PHILCO Factory-Supervised

Shop Practices and Service Techniques

DECEMBER, 1951

SUPPLEMENTS TO SERVICE MANUALS

FIGURE 1

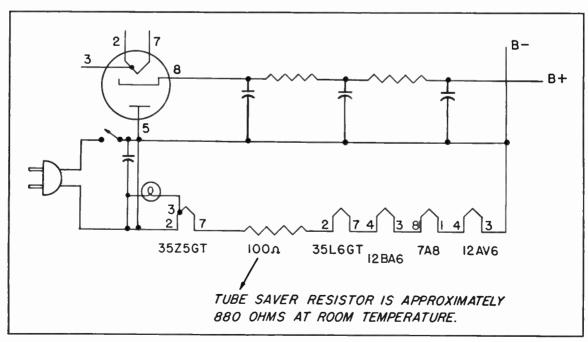
SUPPLEMENT TO PR-1949, SERVICE MANUAL FOR MODELS 52-540, 52-541 AND 52-542

Code 122

This code of the above three models incorporates the "tube saver" resistor. The changes are as follows: The resistor, Part No. 33-1343-3 is wired across a three lug terminal panel at the oscillator end of the chassis. Electrically this resistor is in the series filament string between the output tube, which is now a 35L6, and the 12BA6 IF amplifier, as shown in the accompanying schematic. (Figure 1)
